DCR 093

SWECO change request (please refer to GGMJ-CCRF-000001)

JOB 600 CENTRE POINT
SCALE 1:75 @ A1
DATE 19.08.2016
TITLE CPW Revised Roof Layout
DRG # 600-SK-1098

SK-1098

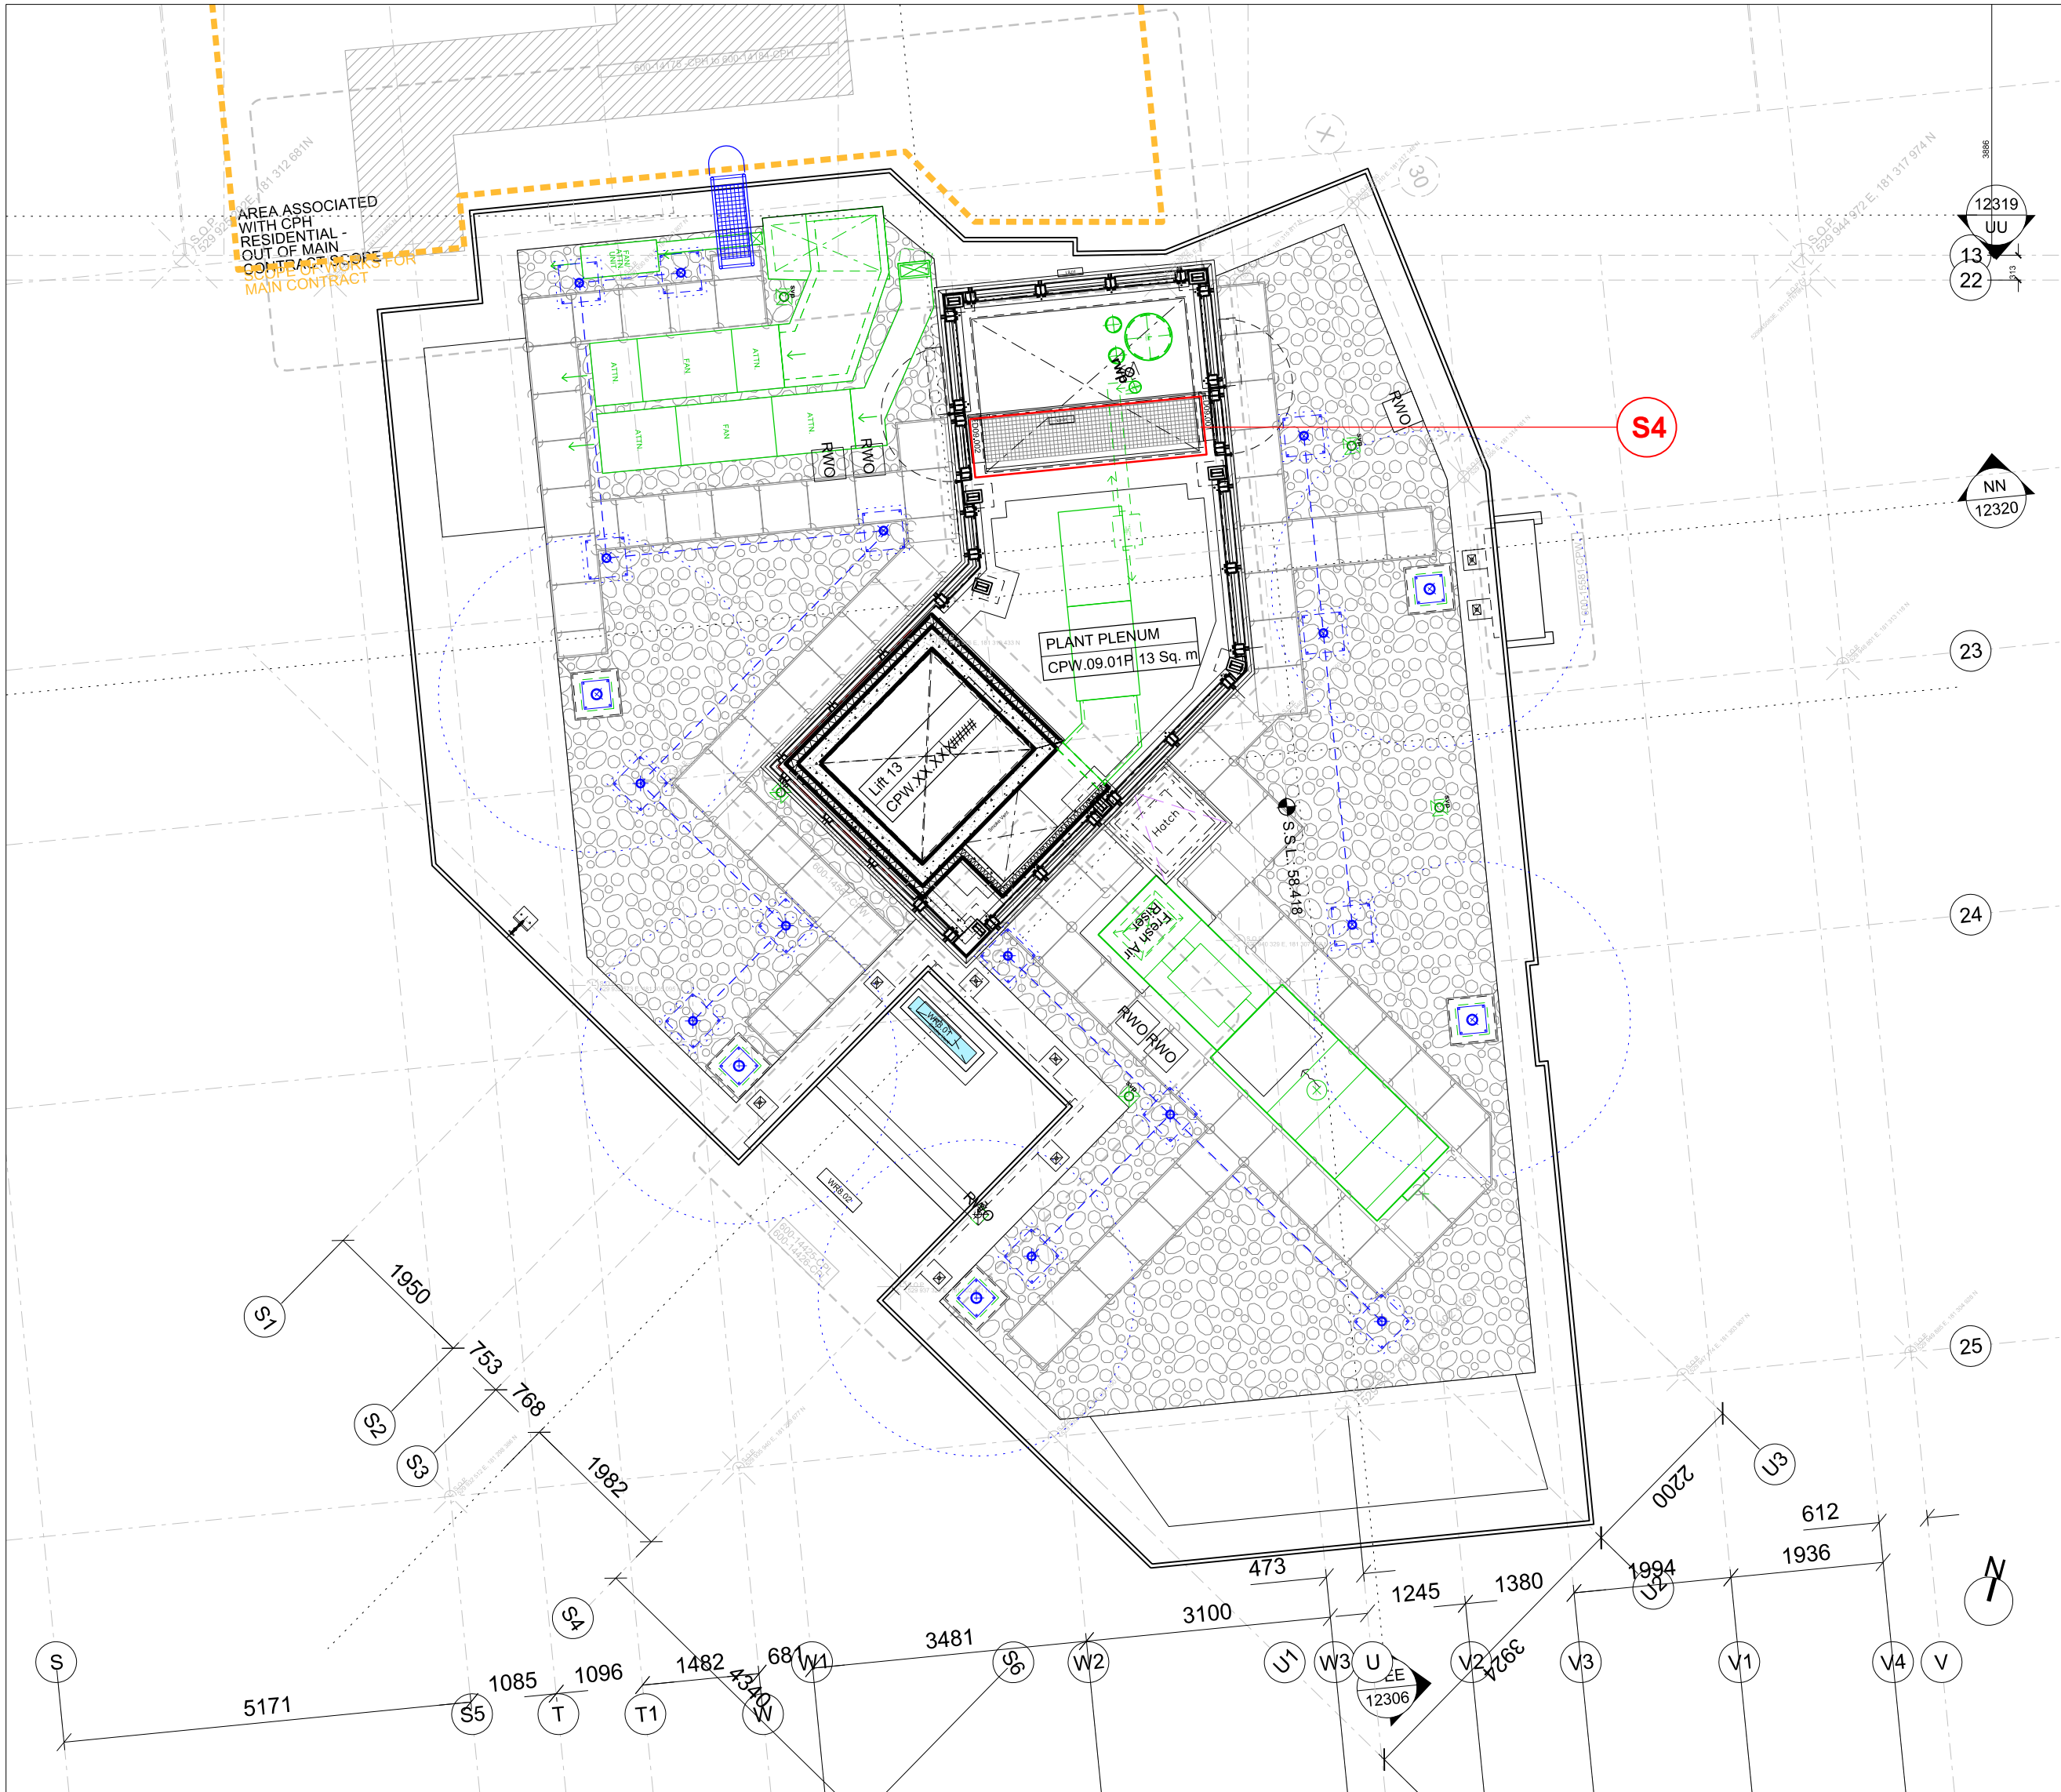
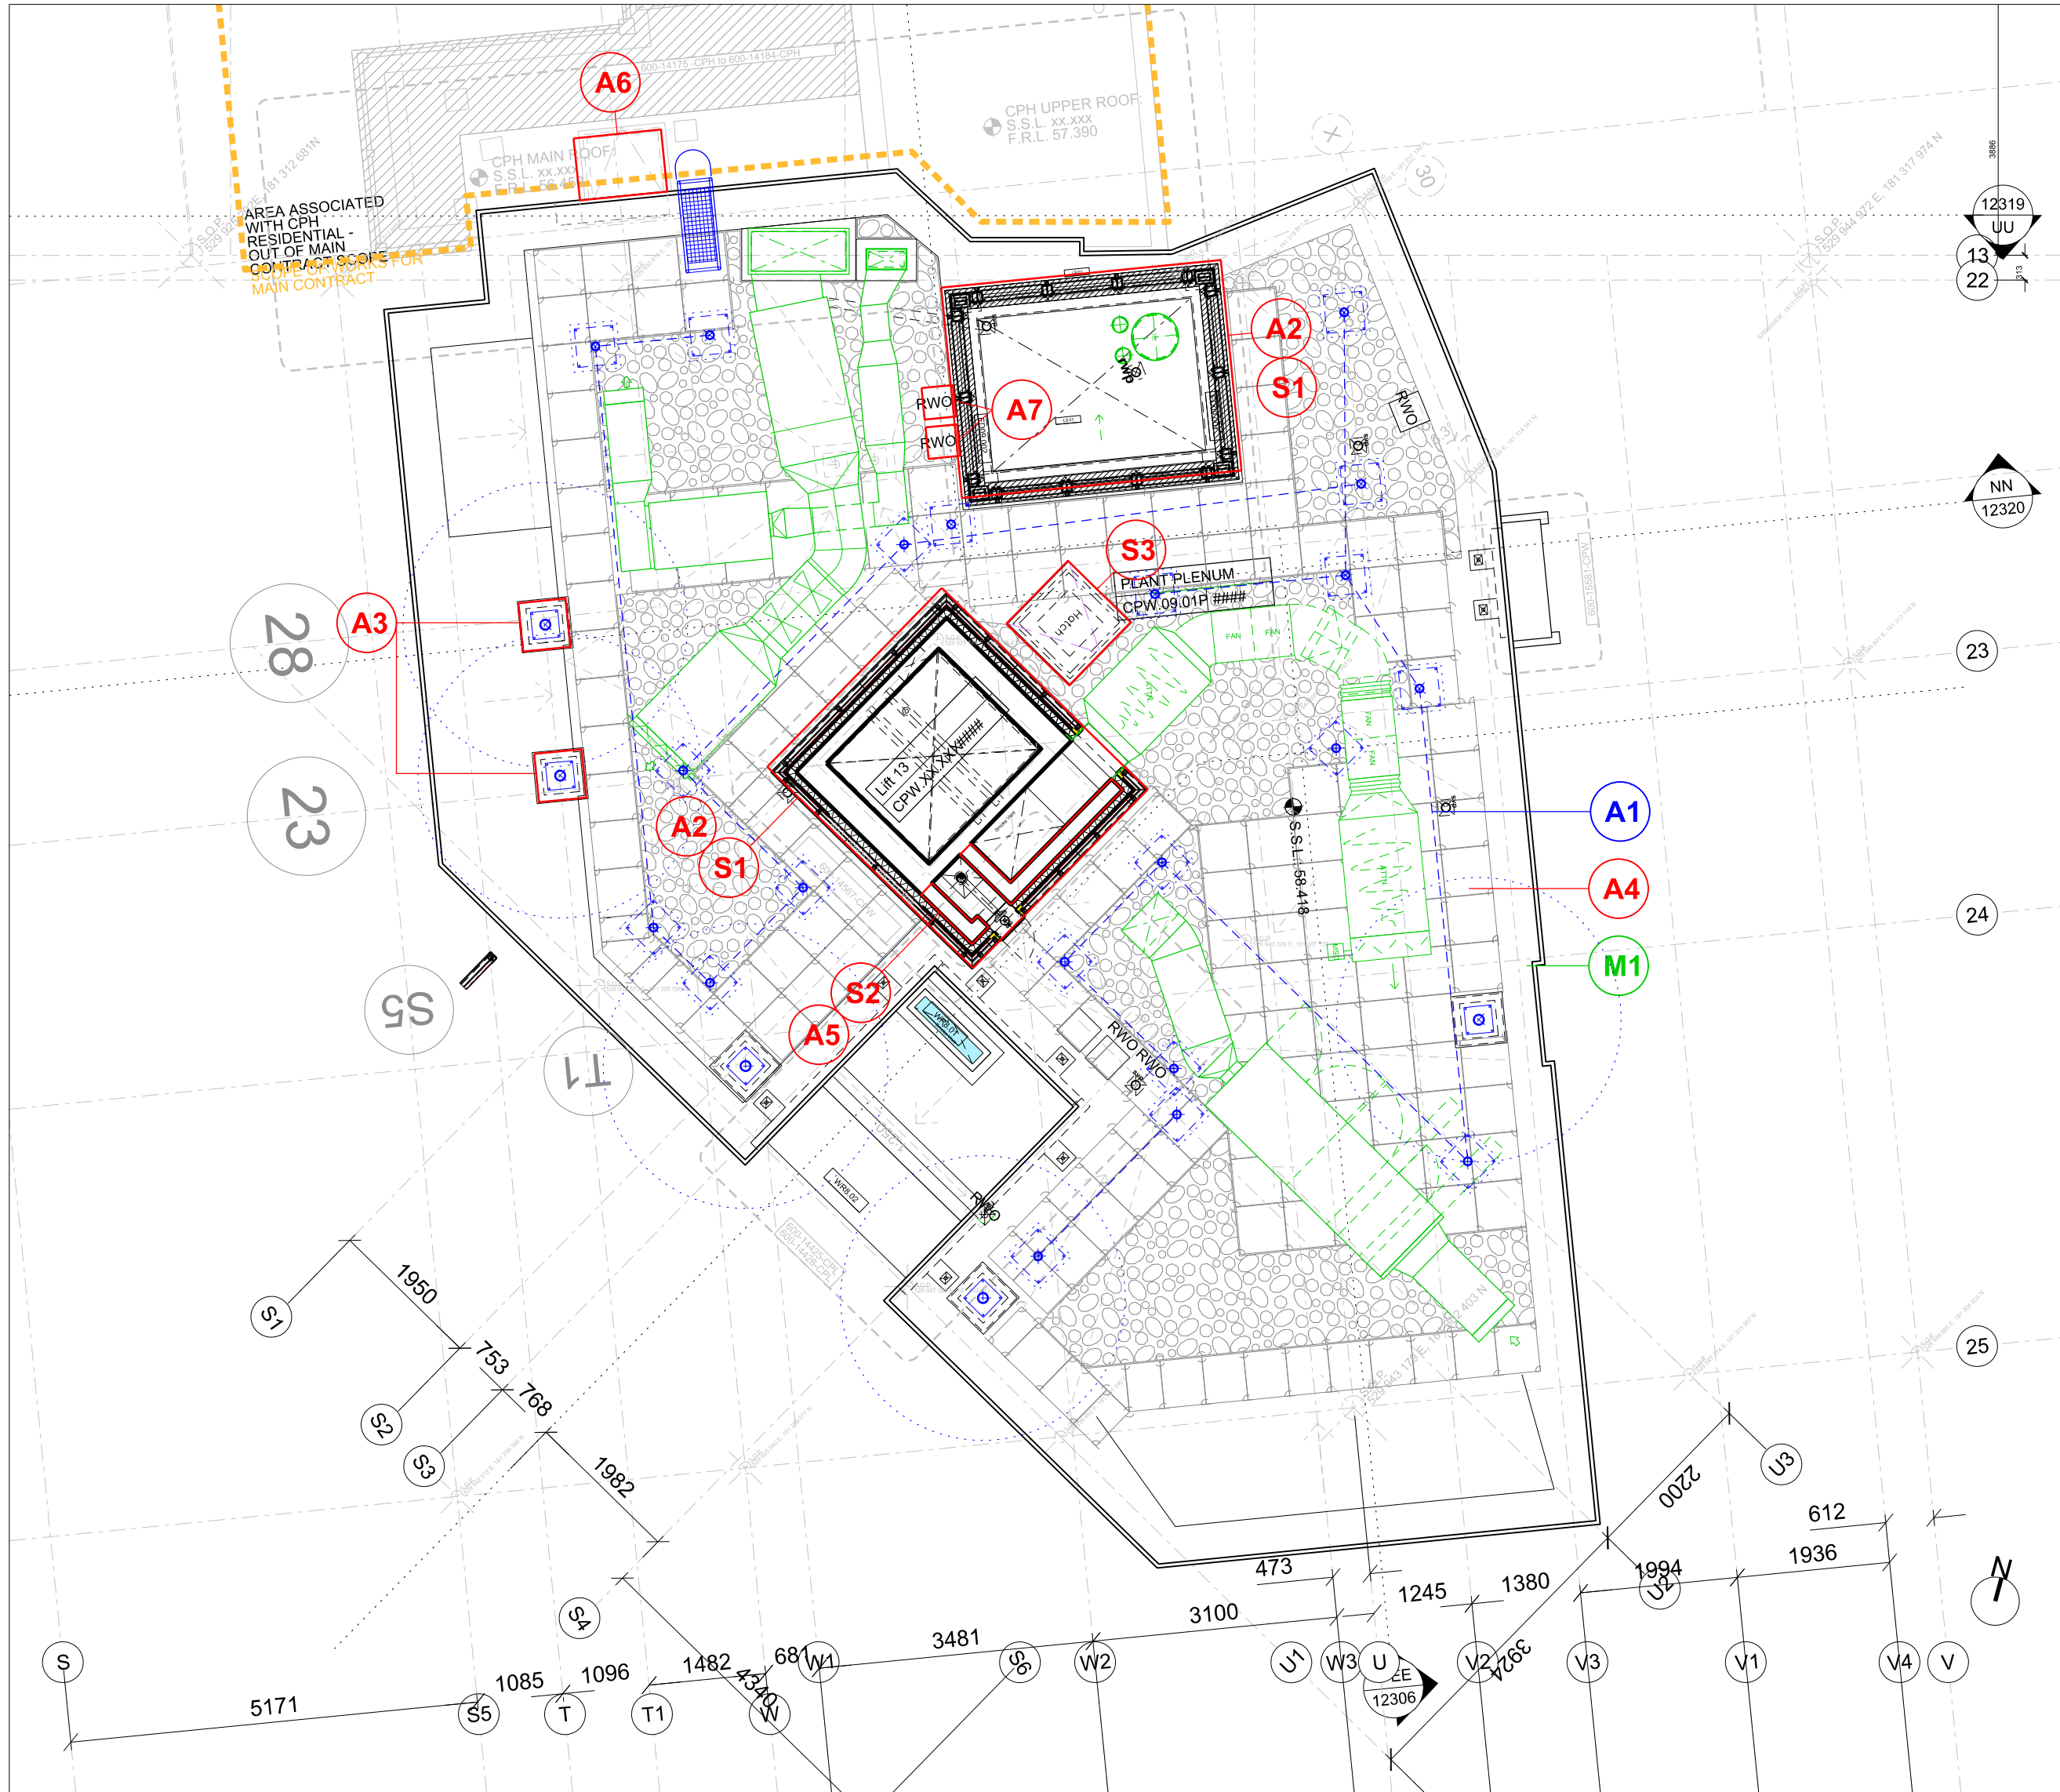
- S1 Reduction in structure to louvred enclosure.
- S2 RC extension to lift overrun/smoke vent, inc. increased shaft height (within current enclosure height)
- S3 Relocation of roof hatch.
- S4 Omission of steel mesh passage to opening.

- A1 Improved roof access and revision to mansafe system to suit new layout.
- A2 Reduction in louvred enclosure, inc. louvred doors, inc. omission of doors ED09.001 and ED09.002.
- A3 Replacement of bespoke rig with 2 standard and revised location
- A4 Rearrangement of roof finishes.
- A5 Addition of dry riser to roof (to match SWECO schematics).
- A6 New AOV to Stair 08 (to match strategy on Sweco & S/C ERs).
- A7 Relocation of 2 x no's RWO

- M1 Addition of external emergency lighting to roof refer to separate change request by SWECO.
